**DEPENDABLE
PRODUCT
NEWS**

Engineering Bulletin: **081110**

Subject: **Pull handle for exit devices location change**

2.24 Standard Entrances Panic Exit Device Locations

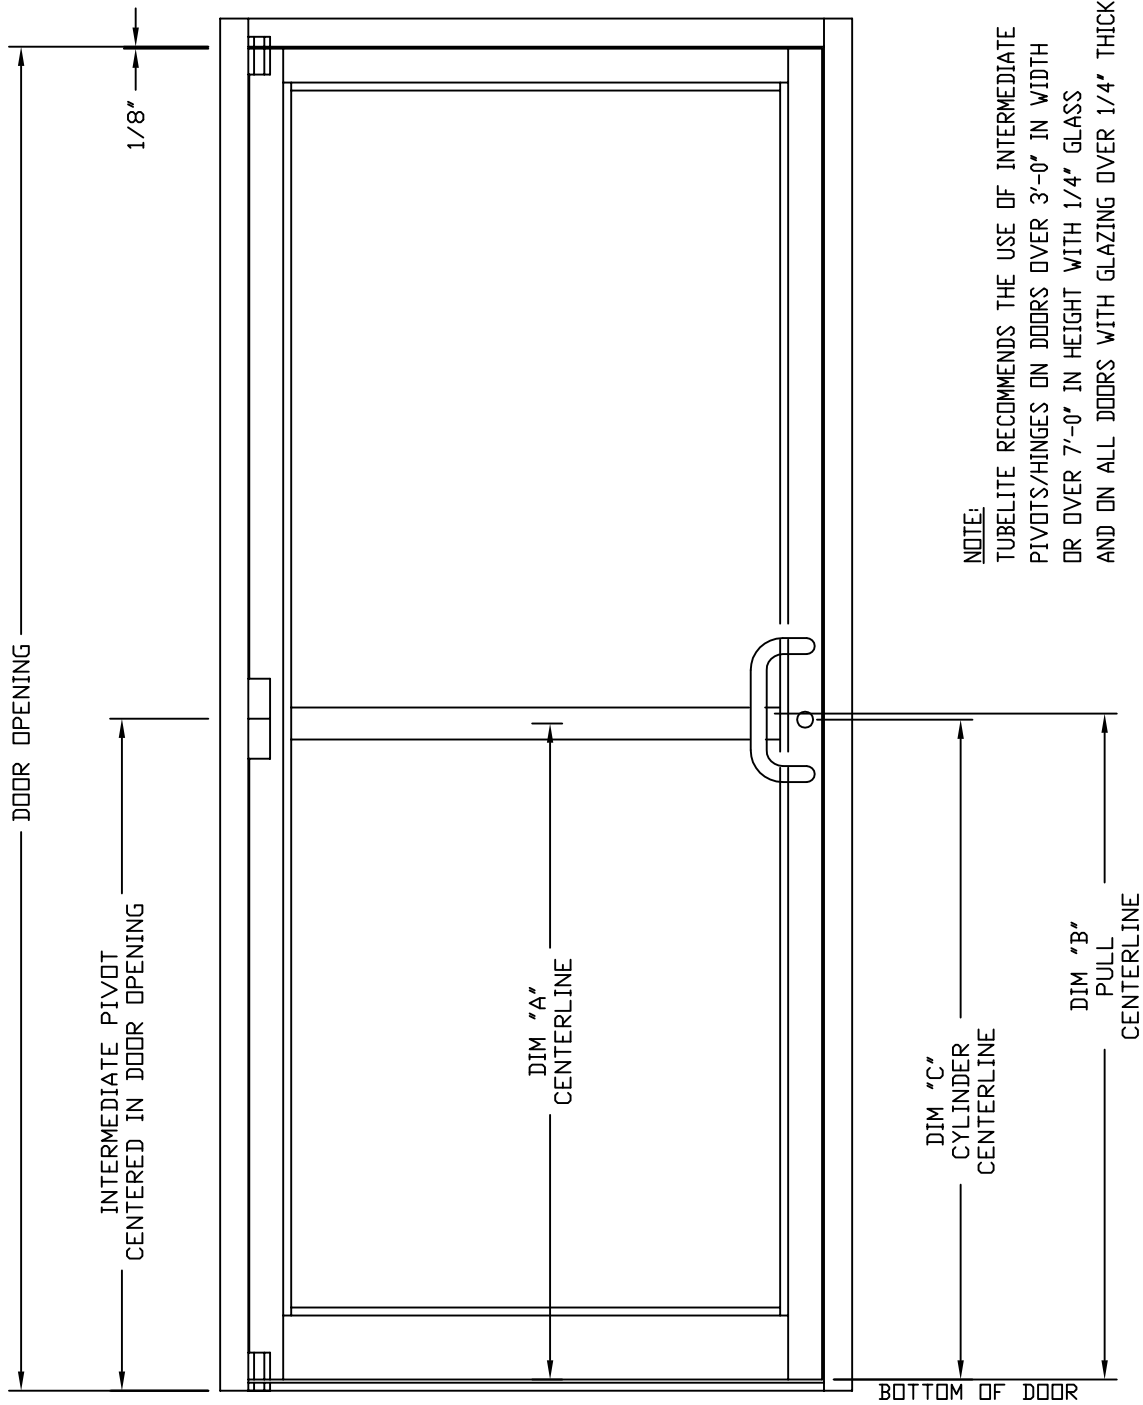
Description: Tubelite will move the location of the pull handle centerline on Panic exit devices on Rim and CVR option. Any order received on September 12th, 2011 and there after will have the new handle location. This will allow the cylinder to be more centered with the pull handle and easier access to lock and unlock. Please see next page for the new pull centerline location.

PANIC	DIM 'A'	DIM 'B'	DIM 'C'
P3692	40 5/8"	41 5/8"	41 9/16"
P3792	40 5/8"	41 5/8"	40 7/8"
P3192	41 1/4"	41 1/4"	41 5/16"
